# McLaren Voluntary Safety Recall Removal of Engine Floor Panel NVH Foam Padding (and Potential Fuel Tank Replacement)

<b>Bulletin type:</b>	Safety Recall Campaign
<b>Reference number:</b>	AFT.027.2020
<b>Affected vehicles:</b>	McLaren 570GT, McLaren GT, McLaren 720S (Coupe and Spider), McLaren Senna
<b>Attention:</b>	All Retailer Staff
<b>Situation:</b>	Voluntary Safety Recall - Potential for corrosion of the fuel tank
<b>Procedure:</b>	Action affected vehicles on next Retailer visit. Please refer to the information outlined in this document to remove the NVH foam padding on the engine floor panel and inspect the fuel tank for possible corrosion
<b>Date:</b>	17 <sup>th</sup> June 2020

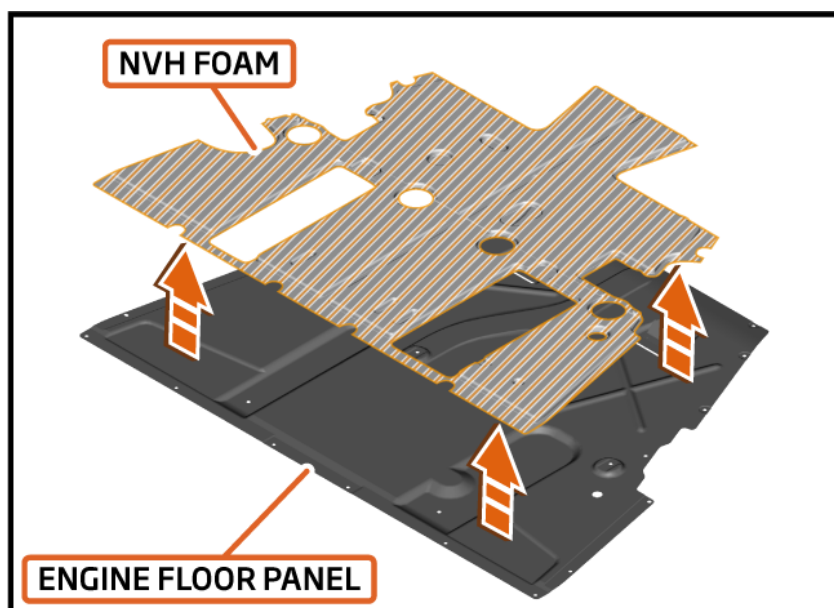
This voluntary recall relates to the fact that the Noise, Vibration and Harshness (NVH) foam padding positioned on the underside of the fuel tank can, in some instances, trap corrosive moisture, which can over time cause corrosion of the fuel tank. If not addressed, the corrosion may cause fuel vapour or liquid fuel to leak from the fuel tank, which could increase the risk of a fire.

1. Remove the engine floor panel
2. Inspect the fuel tank for signs of corrosion and / or leakage
  - a. If no signs of corrosion and / or leakage are found, continue to step 3
  - b. If signs of corrosion and / or leakage are found, please submit a Technical Request - Refer to section 4.2 below
3. Remove all the NVH foam padding on the engine floor panel
4. Clean off the residual adhesive which is left on the engine floor panel
5. Re-install the engine floor panel
